State of New Mexico
 Energy, Minerals and Natural Resources

OIL CONSERVATION DIVISION
 1220 South St. Francis Dr.
 Santa Fe, NM 87505

SUNDRY NOTICES AND REPORTS ON WELLS (DO NOT USE THIS FORM FOR PROPOSALS TO DRILL OR TO DEEPEN OR PLUG BACK TO A DIFFERENT RESERVOIR. USE "APPLICATION FOR PERMIT" (FORM C-101) FOR SUCH PROPOSALS.)	
1. Type of Well: Oil Well <input type="checkbox"/> Gas Well <input checked="" type="checkbox"/> Other	
2. Name of Operator EOG Resources, Inc.	
3. Address of Operator 104 South Fourth Street, Artesia, NM 88210	
4. Well Location Unit Letter <u>J</u> : <u>1980</u> feet from the <u>South</u> line and <u>2200</u> feet from the <u>East</u> line Section <u>8</u> Township <u>18S</u> Range <u>26E</u> NMPM <u>Eddy</u> County	
11. Elevation (Show whether DR, RKB, RT, GR, etc.) 3398'GR

EOG Resources, Inc. plans to plug and abandon this well as follows:

Torrington ZK 1 Proposed

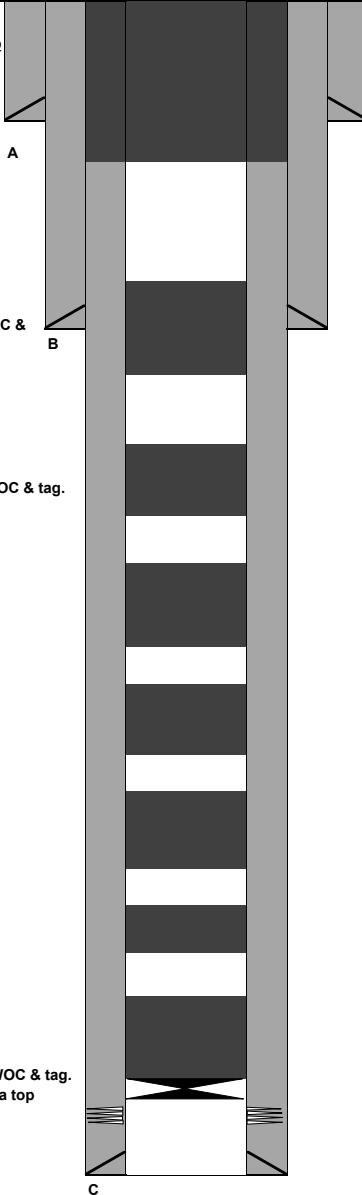
Run CBL to surface.

Spot 25 sx cmt @ 8010' - 7810' - T. of Strawn

Must be plugged by 3/16/2023
